SAFETY RECALL

No. 00V-101

**SUBJECT: Safety Recall
CNG Copper Vent Line**

UNITS INVOLVED: All 1991 thru 1996 model year Escort RE and Transmark RE buses powered by CNG (compressed natural gas) engines.

PROPOSED RETROFIT
OF CNG VENT SYSTEM

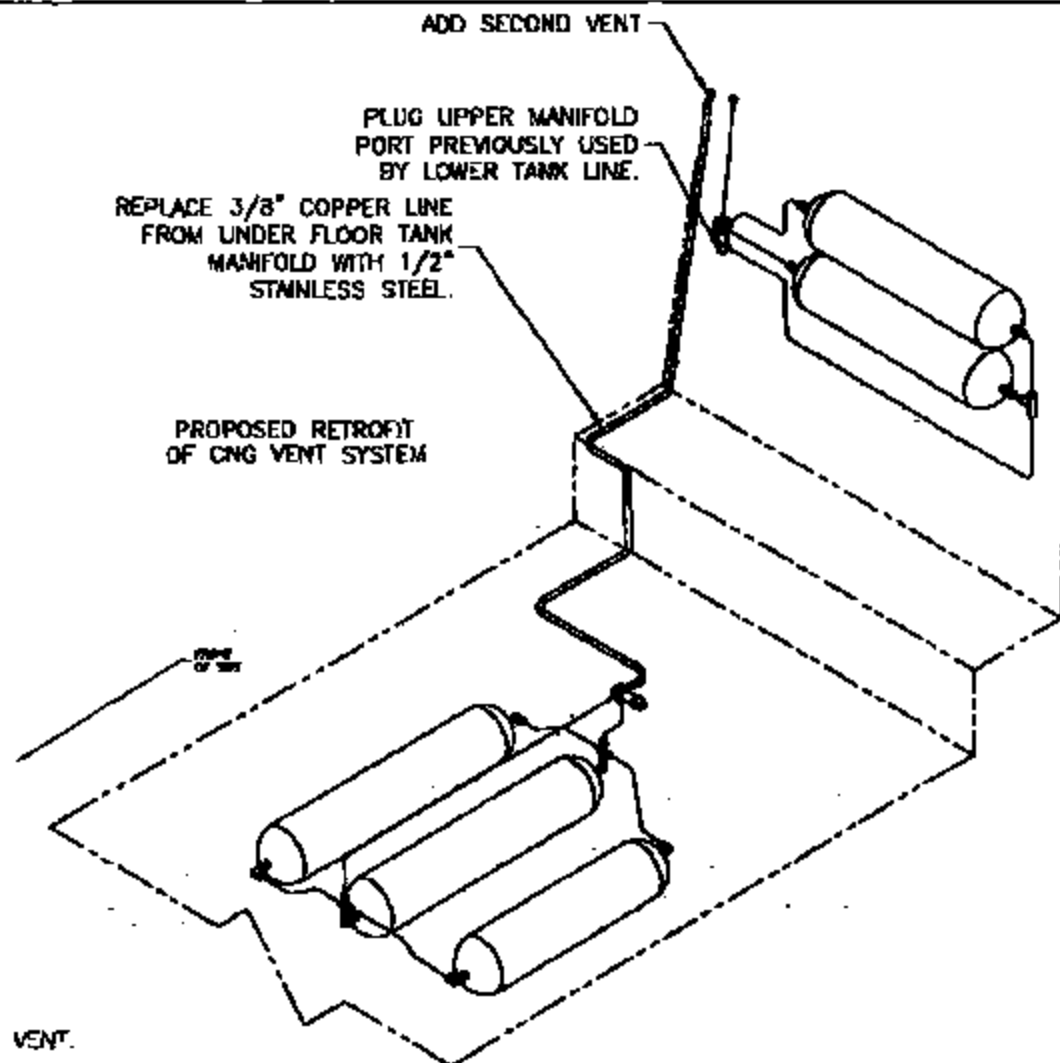
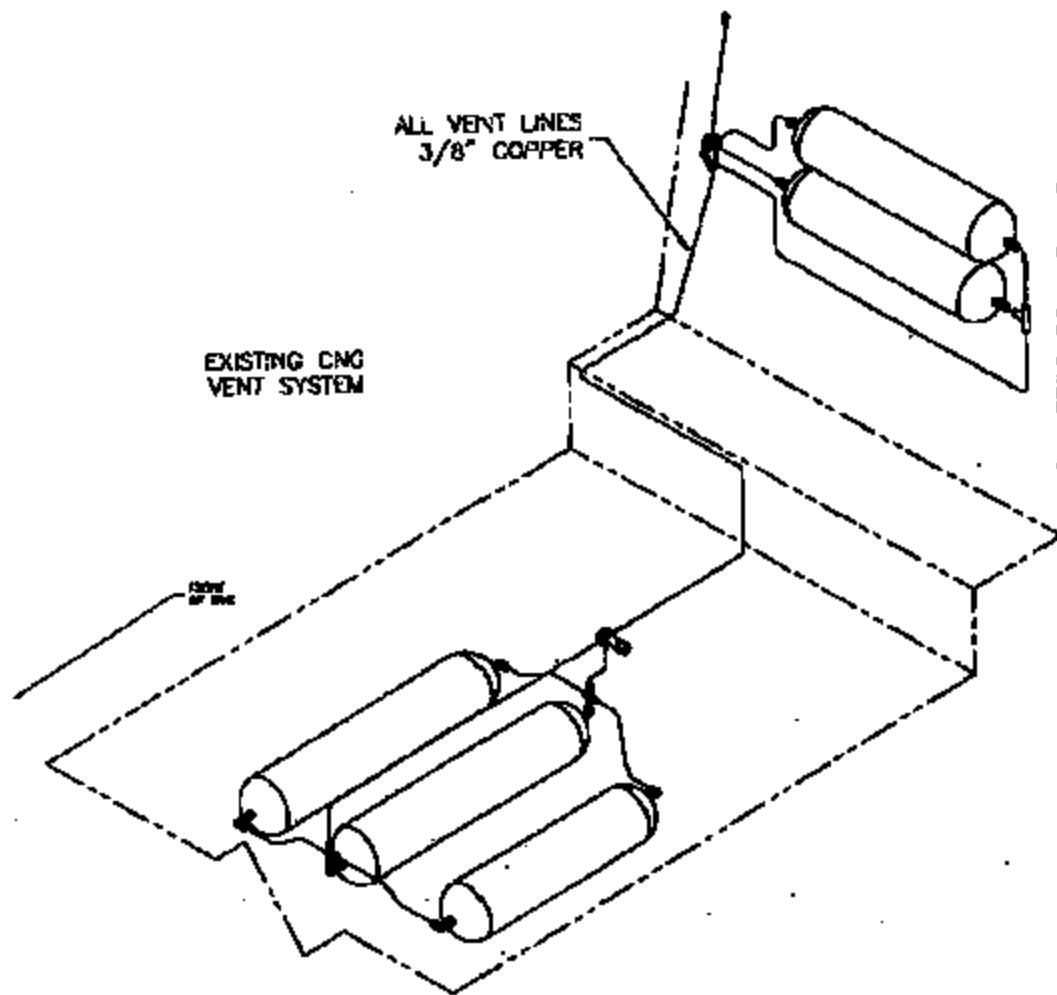
ElDorado National has determined that a defect which relates to motor vehicle safety exists in certain 1991 thru 1996 model year Escort RE and Transmark RE buses, powered by CNG engines. Even though these buses were in compliance with all regulations, ElDorado National has determined that the 3/8" copper tubing used as a CNG vent line could result in inadequate venting in certain conditions. Therefore, ElDorado National has developed an improved venting system using 1/2" stainless steel tubing to replace the existing 3/8" copper tube vent line.

Therefore, upon receipt of the tubing retrofit kits, all owner/operators of the above mentioned vehicles should immediately replace the 3/8" copper vent line from the lower manifold to the roof (see attached drawing No. 22009000) with 1/2" stainless steel tubing. Note: This work must be performed by CNG certified mechanics.

ElDorado National will supply, at no charge, a 1/2" stainless steel tubing retrofit kit, along with fittings and hardware. See attached drawing No. 22009100 for routing of the new stainless steel vent line.

1. REMOVE COPPER LINE BETWEEN UNDER FLOOR TANK MANIFOLD AND UPPER MANIFOLD.
2. INSTALL SUPPLIED 1/2" STAINLESS STEEL KIT, IN PROPER MANNER, AS SHOWN.
3. DRILL 1" HOLE IN ROOF PANEL AND INSTALL SECOND ROOF VENT.
4. PLUG BOTTOM HOLE OF UPPER MANIFOLD.
5. VENT LINE SHOULD BE SECURED EVERY 24".
